Access Compliance Report

Public Rights-of-Way

Intersection ID: 30299	Main Street: DERRYFIELD_DR	Cross Street: MUMFORD_LN	Location: NE
ADA ID: 1820BDC79E87	Ramp Type: PerpDiag	Initial Pass/Fail: Pass	Overall Compliance: No
Codes/Mitigation Info/Possible Solution		Field Measurements/Component Compliance

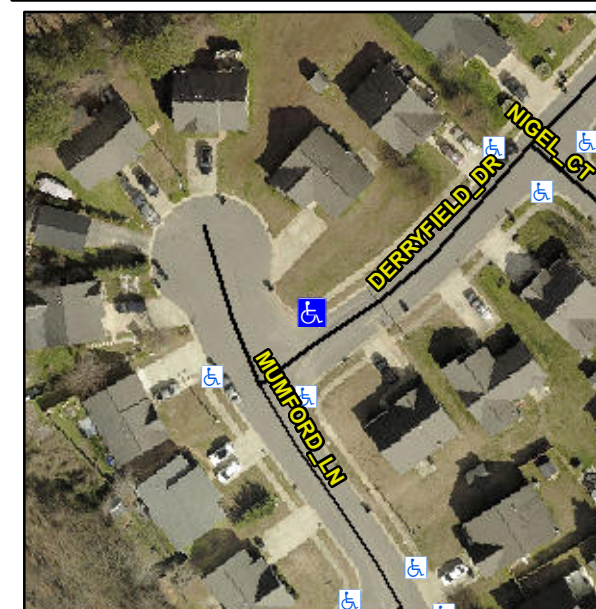
Not Found, R304.5.3, R304.2.1, R304.2.2-Perp, R304.3.2-Para, R305.2, R302.7, R302.7.2

Compliance	Description	Data	Compliance	Description	Data
N/A	Ramp Length (in)	32.0	Yes	Ramp Slope (%)	5.6
Yes	Ramp Width (in)	69.0	No	Ramp XSlope (%)	2.5
N/A	Flare Type LT	Sloped	N/A	Flare Type RT	N/A
N/A	Flare Slope LT (%)	1.9	N/A	Flare Slope RT (%)	5.6
N/A	Flare Traversable LT?	No	N/A	Flare Traversable RT?	No
No	Landing Length (in)	N/A	Yes	DWS Provided?	Yes
No	Landing Width (in)	N/A	Yes	DWS Contrast?	Yes
No	Landing Slope (%)	N/A	Yes	DWS Length (in)	25.5
No	Landing X Slope (%)	N/A	Yes	DWS Full Width?	Yes
N/A	Landing Curb? (Y/N)	No	No	DWS Offset (in)	2.5
N/A	Shared Landing?	No			
No	Gutter Ponding?	Yes	Yes	Gutter Slope (%)	1.9
No	Gutter Lip Ht (in)	0.5	No	Gutter X Slope (%)	2.2
N/A	Painted X Walk1?	No	N/A	Painted X Walk2?	No
	X Walk 1 Direction	To W		X Walk 2 Direction	To SW
N/A	X Walk 1 Width (in)	N/A	N/A	X Walk 2 Width (in)	N/A
	X Walk 1 Slope (%)	0.8		X Walk 2 Slope (%)	1.0
	X Walk 1 X Slope (%)	1.3		X Walk 2 X Slope (%)	1.5

Remove & Replace Curb Ramp With Two New Directional Ramps or Equivalent. Remove & Replace Gutter.
